International
Civil Aviation
Organization

Ref.: SP 65/4-13/24

14 June 2013

Subject: Proposal for the amendment of PANS-OPS, Volumes I and II regarding procedure design criteria and charting requirements to support performance-based navigation (PBN) as well as helicopter point-in-space (PinS) approach and departure operations with consequential amendments to Annexes 4; 6, Parts I, II and III; 14, Volume II; 15 and the PANS-ABC

Figure III-1-1-1. Merging segments of different widths

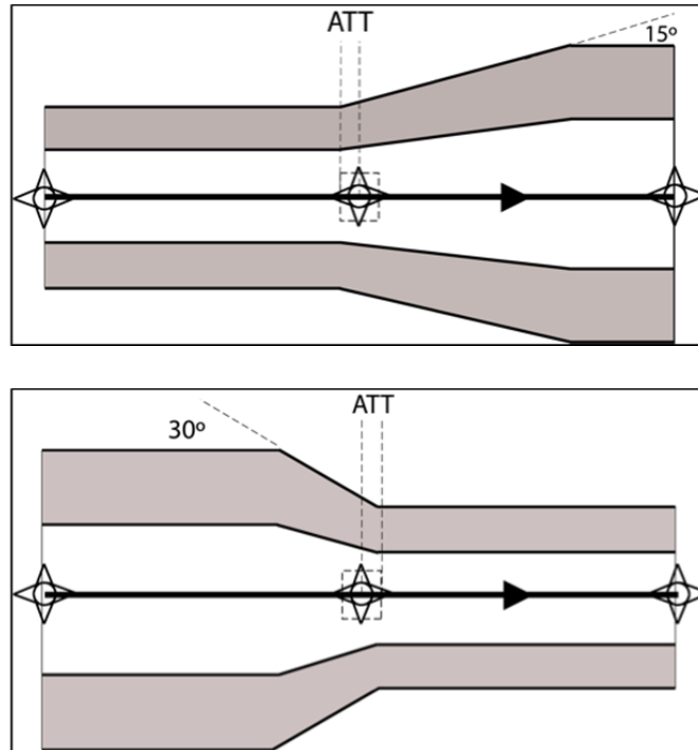
1.4.3 Merging Segments of different widths

Larger area semi width values are merged, at 30° to the nominal track, to achieve smaller area semi width values at one ATT after the designated waypoint. Smaller semi area width values are splayed, at 15° to the nominal track, to larger area semi width values from one ATT prior to the designated waypoint. This is illustrated in Figure III-1-1-1. The merging and splaying at flight phase interfaces is addressed in paragraph 1.4.4.

Figure III-2-2-13. RF turn protection

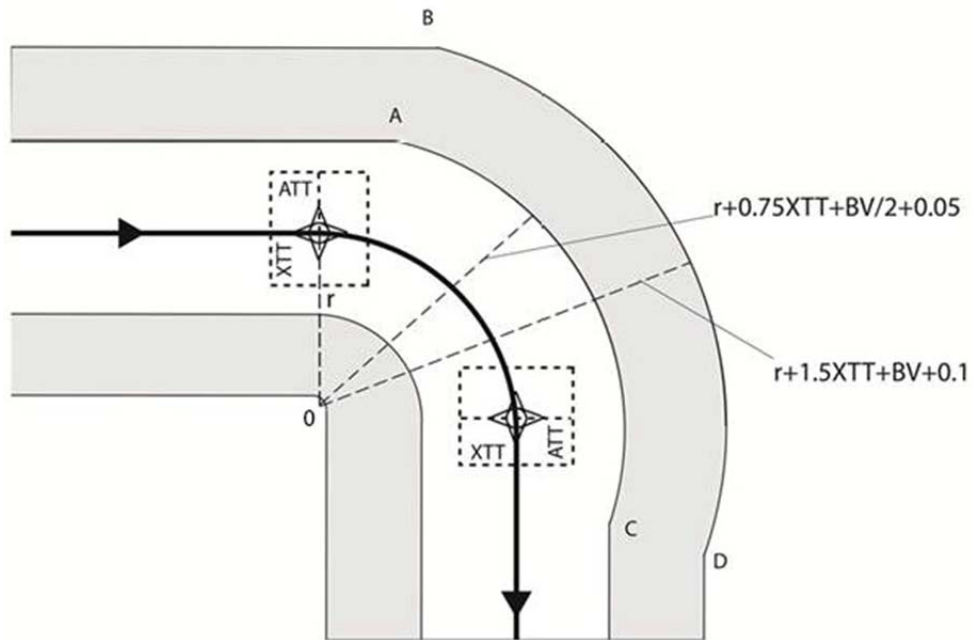
- a) centred on point O (centre of the turn);
- b) having a radius $r + [0.75 \cdot \text{XTT} + \text{BV}/2] / \cos 45^\circ$ or $r + 0.75 \cdot \text{XTT} + \text{BV}/2 + 93 \text{ m}$ (0.05 NM); and
- c) delimited by the edges of the adjacent straight segments (points J and M in Figure III-2-2-13 points A and C in Figure III-2-2-13).

- a) centred on point O;
- b) having a radius of $r + 1.5 \cdot \text{XTT} + \text{BV} + 186\text{m}$ (0.1NM);
- c) delimited by the edges of the adjacent straight segments (points B and D in Figure III-2-2-13).

- centred on point I at a distance of $[0.75 \cdot XTT + BV/2] / \cos 45^\circ$ from the centre of the turn (point O) centred on point O;
- having a radius $r - [0.75 \cdot XTT + BV/2]$; and
- delimited by the edges of the adjacent straight segments (points P and R in Figure III-2-2-13).

Figure III-2-2-14. Splay in RF turn

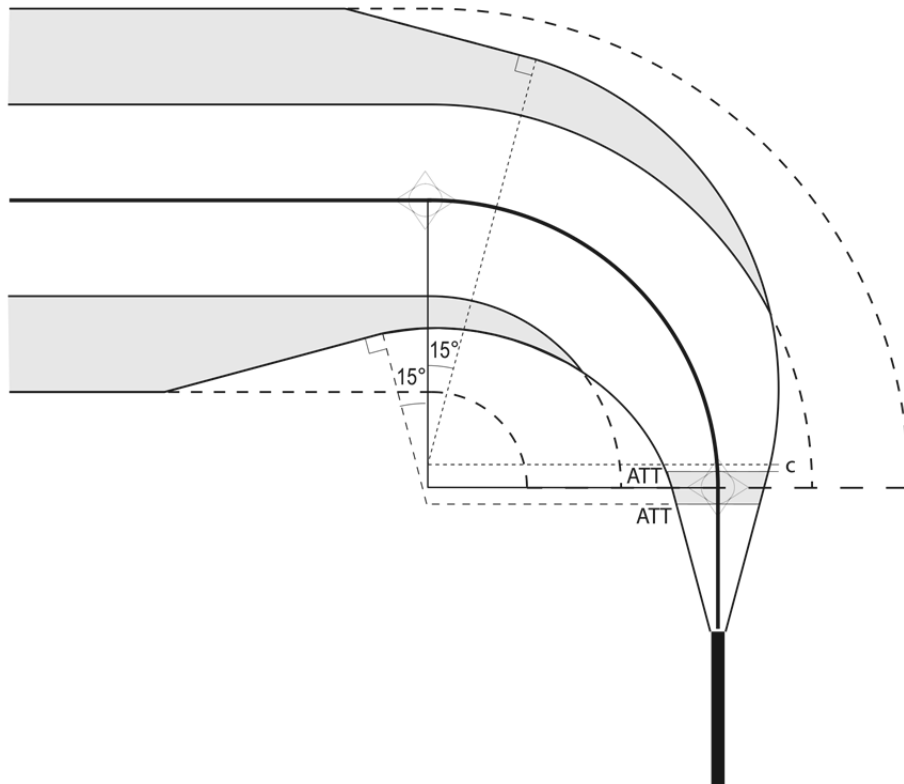
$$r_t = \max[r_o, (r_s - (2\pi r_s \frac{\alpha}{360}) \tan 15^\circ)]$$

The inner spiral arc shall start prior to the waypoint at the start of the RF turn, at a distance corresponding to the earliest ATT. It shall terminate abeam the succeeding waypoint, when the 15° splay will continue on the subsequent leg. This is illustrated in Figure III-2-2-14.

Figure III-3-1-1. RF initial departure

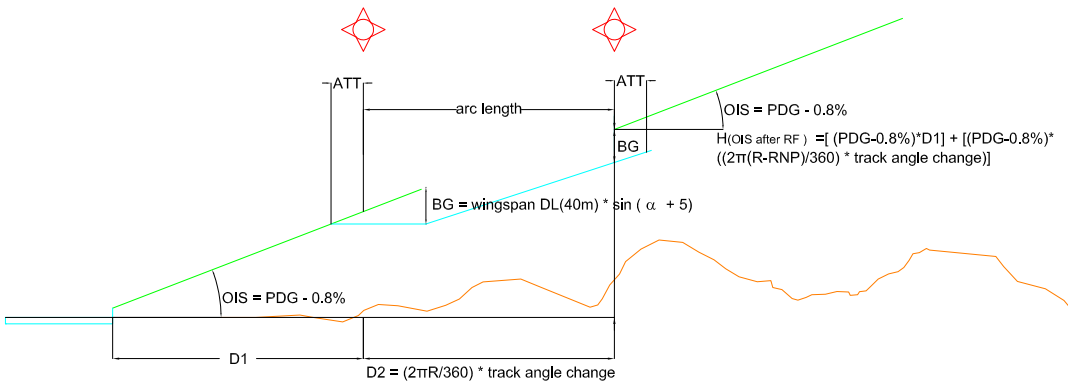
The following criteria apply to RF turns on departures:

- If the OIS does not reach 400 ft at the start of the RF turn, an additional gradient and an altitude restriction at the waypoint shall be published.
- The path descriptor sequence for initial legs should be IF/TF/RF/TF or IF/TF/RF/RF/TF.

Figure III-3-4-4. Final approach surfaces above 5 000 ft

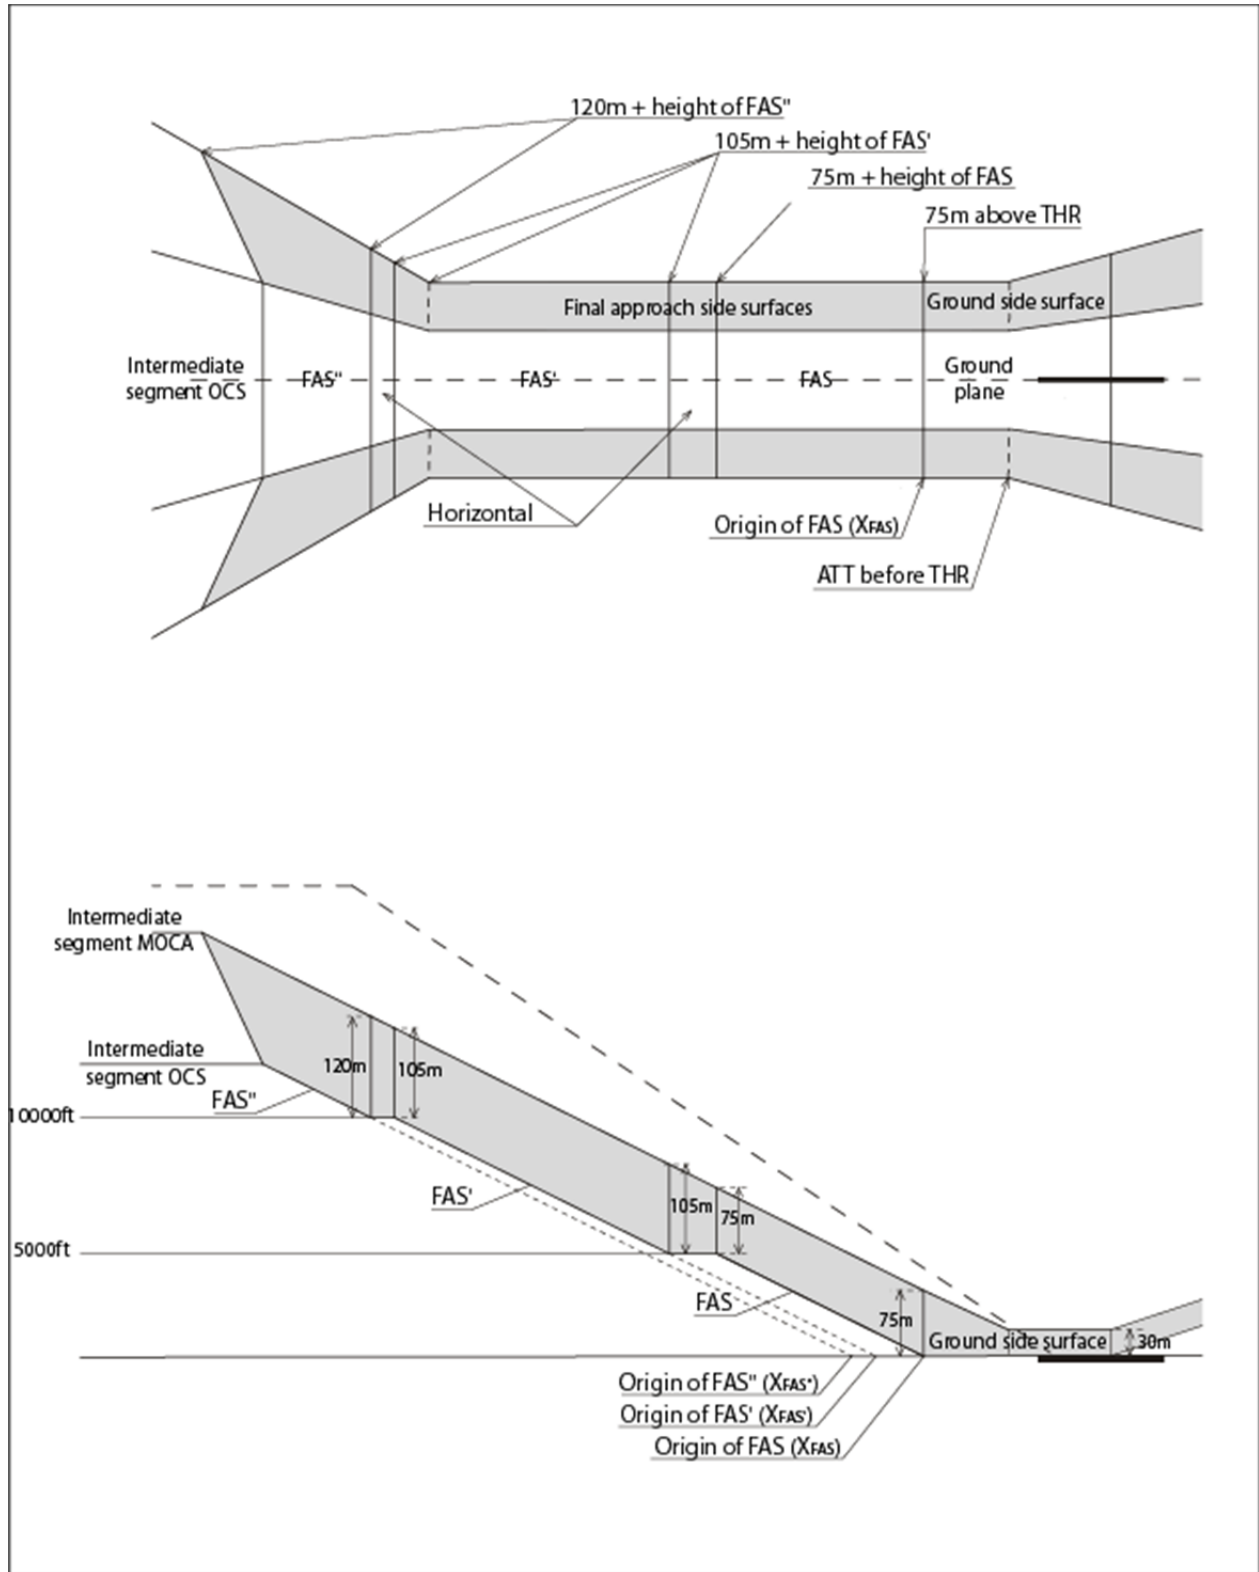
4.3.4.2.4 *Approach surfaces above 5 000 ft* (see Figure III-3-4-4). When the horizontal OCS of the intermediate segment is above 5 000 ft AMSL, the FAS above 5 000 ft is replaced by a revised final approach surface, FAS', between 5 000 ft and 10 000 ft and by a revised final approach surface, FAS'', above 10 000 ft. The surfaces FAS'', FAS' and FAS are connected by horizontal planes at 10 000 ft and 5 000 ft respectively.

The outer edges of the side surfaces associated with the horizontal planes connecting FAS'', FAS' and FAS are reduced from 120 m to 105 m and from 105 m to 75 m, respectively. This result in twisted side surfaces associated with the horizontal planes.

Figure III-3-4-5 a) and b). Missed approach obstacles

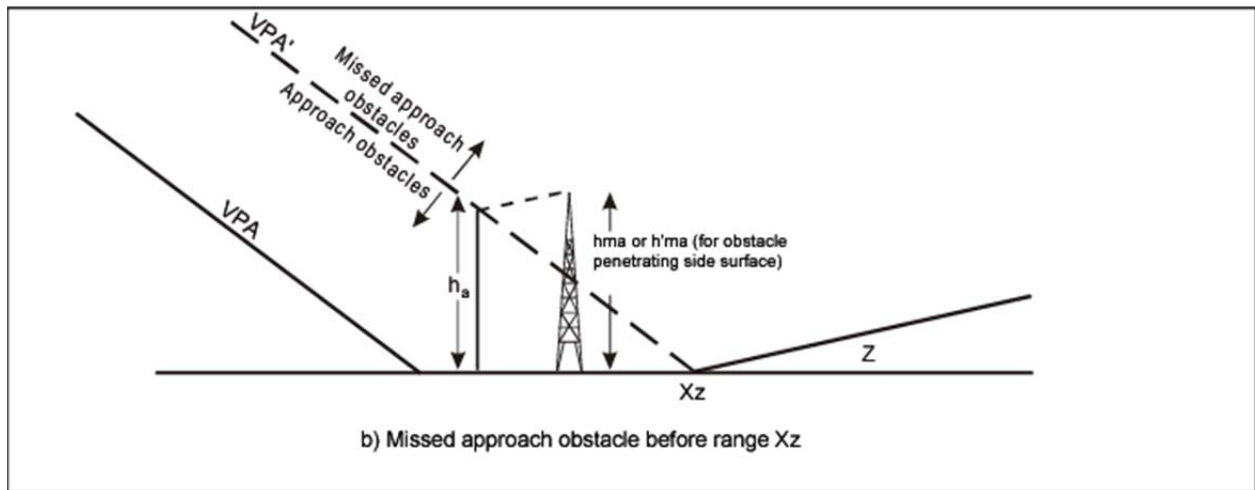
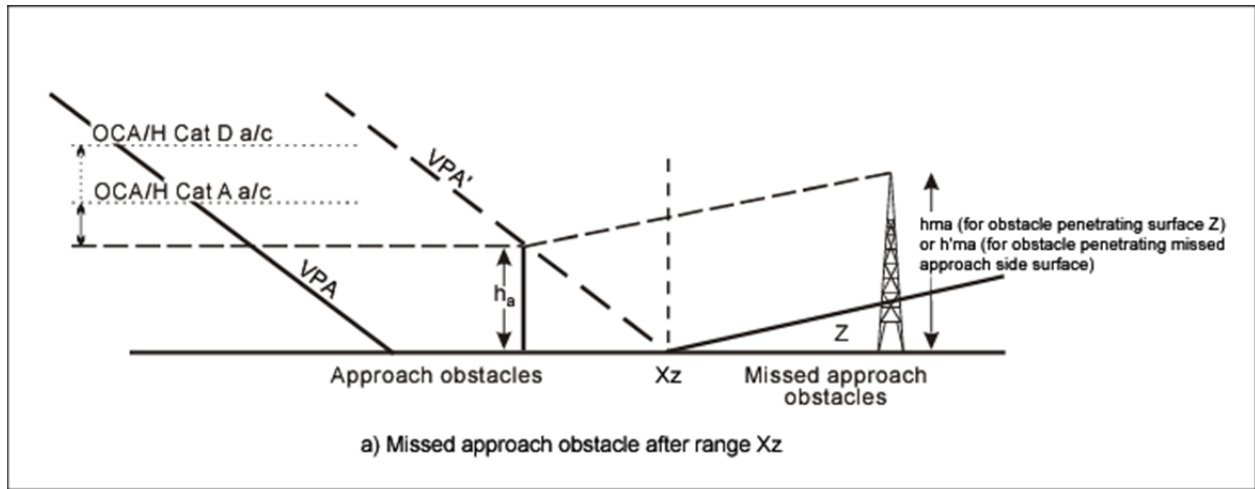
- a) Approach obstacles are those located between the beginning of the final approach segment and the origin of the Z surface.
- b) Missed approach obstacles are those located in the remainder of the missed approach segment (see Figure III-3-4-5 a)).

Obstacles located before the origin of the Z surface may be considered as missed approach obstacles if they penetrate a surface VPA', parallel to the promulgated VPA and with origin at X_z. [i.e. obstacle height greater than [(x-X_z) tanVPA] (see Figure III-3-4-5 b)).

Figure III-3-4-6. Missed approach side surface penetration

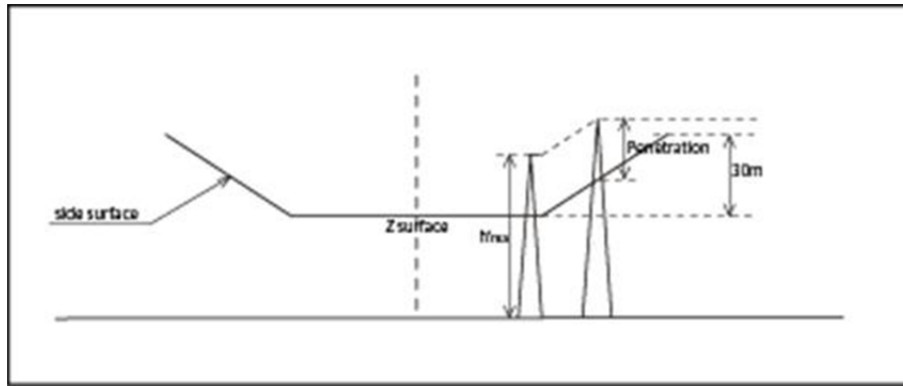
where h'_{ma} is the amount of the penetration plus the height of the inner edge of the side surface at the along-track distance of the penetrating obstacle (see Figure III-3-4-6).

Figure I-4-5-7-b). Visual segment surface other approach procedures normal straight-in approach

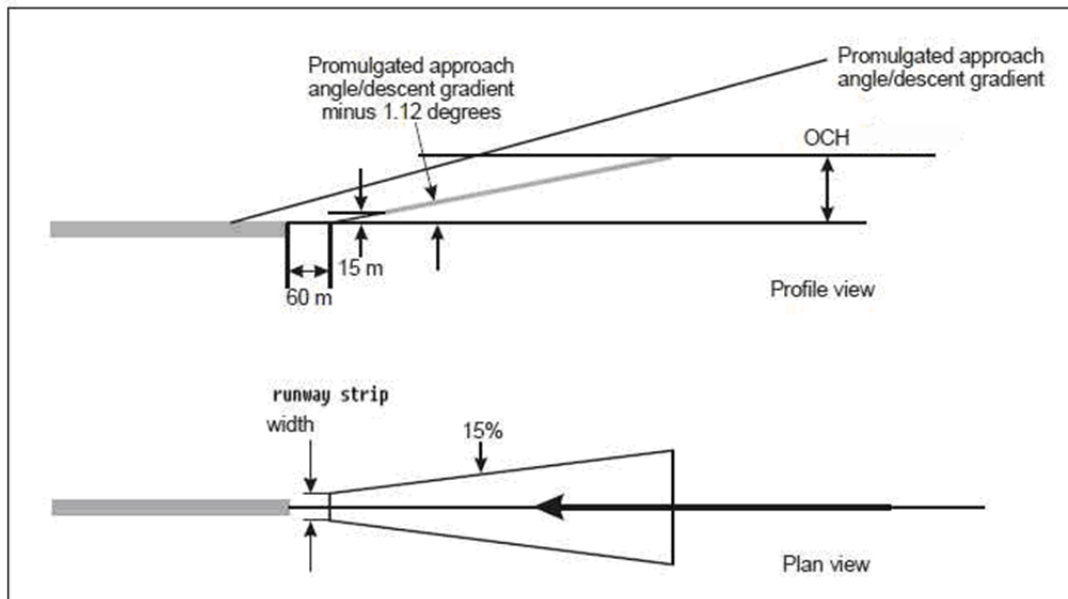
- 1) a base width of 300 m (150 m either side of the extended runway centre line) for a Code 3 and 4 runway and 150 m (75 m either side of the extended runway centre line) for Code 1 and 2, equal to the runway strip width originating 60 m prior to the runway threshold, splaying 15 per cent on either side of the extended runway centre line, and terminating at the point where the height of the surface reaches the OCH (see Figure I-4-5-7-b));

Editorial note.— Amend Figure I-4-5-7-b) as follows:

Figure IV-2-18. HAS diagram (showing both water and land surfaces) for PinS approach procedure with a “Proceed VFR” instruction

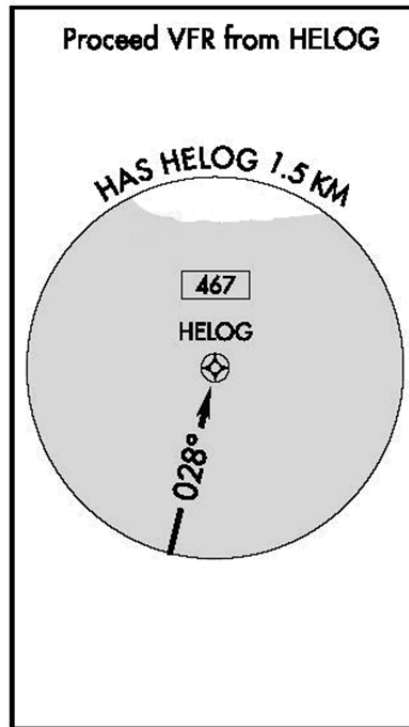
2.11.2 *HAS diagram requirements.* The radius of the HAS diagram, centred on the MAPt of the PinS approach procedure with a “proceed VFR” instruction, is at least 1.5 km (0.8 NM). This minimum value may be increased depending on State-specific requirements for helicopter VFR operations. The difference in height between the OCA and the elevation of the highest terrain or water within 1.5 km (0.8 NM), or other higher value required by the State, of the MAPt shall be charted. The inbound course to the MAPt shall also be charted. An example of a HAS diagram is depicted in Figure IV-2-18. The HAS value in the example is 467 ft and the final approach course to the MAPt is 028°.

Figure IV-3-1. Representation of a PinS RNP APCH supporting LNAV and LPV minima

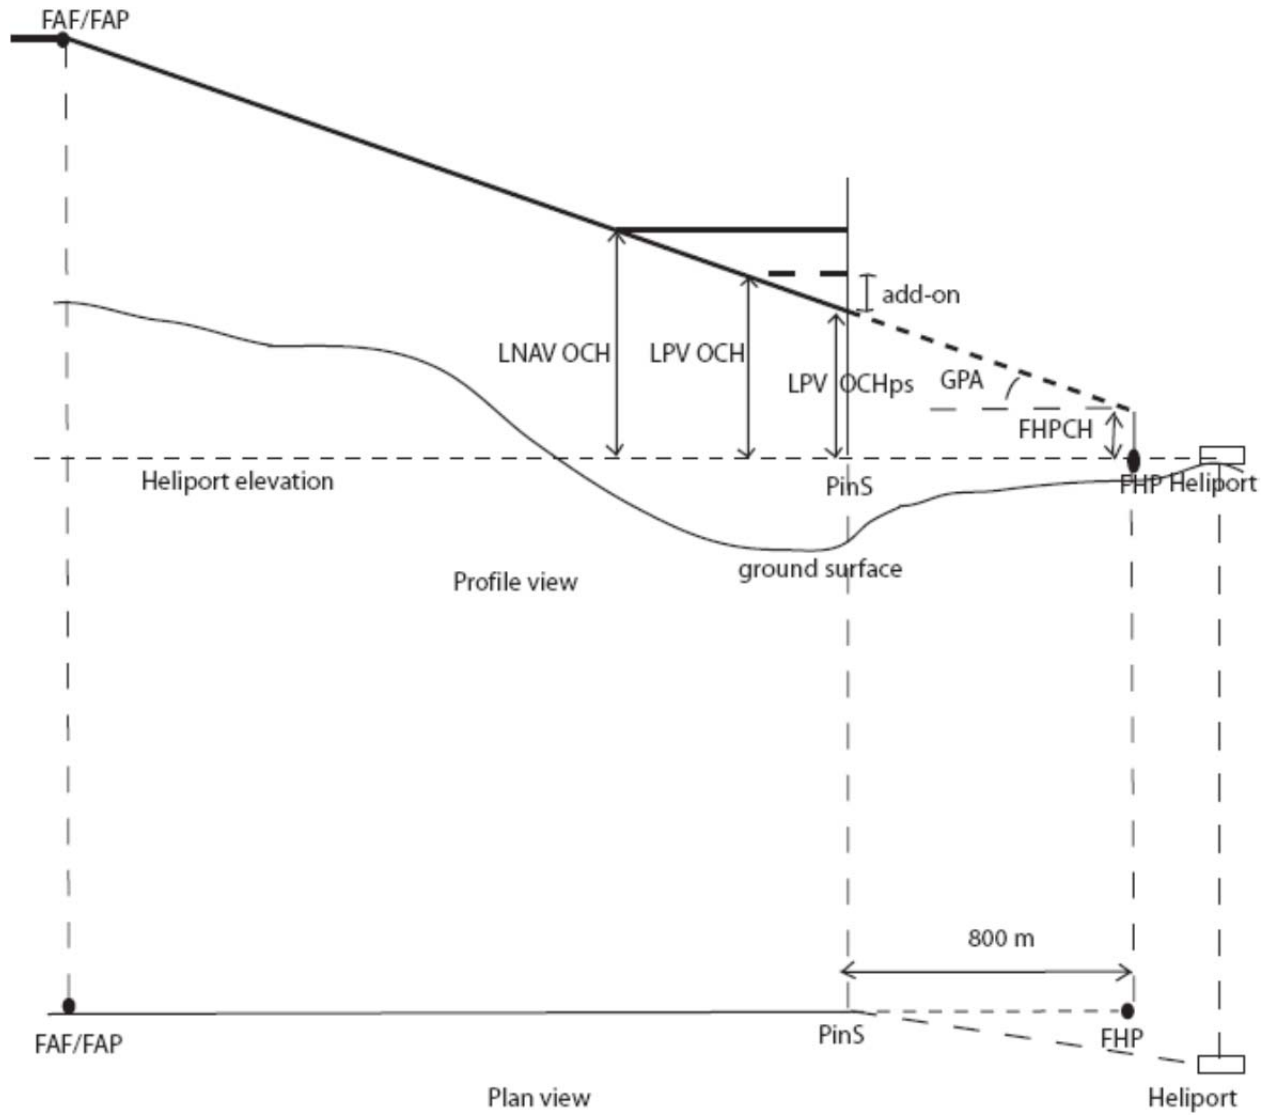
3.2.1 *FHP (fictitious heliport point) and PinS locations.* The final approach segment, ending at the PinS, is oriented on a FHP (fictitious heliport point). The FHP elevation is equal to the elevation of the landing heliport. The distance between the PinS and the FHP is equal to 800 m. This is illustrated in Figure IV-3-1.
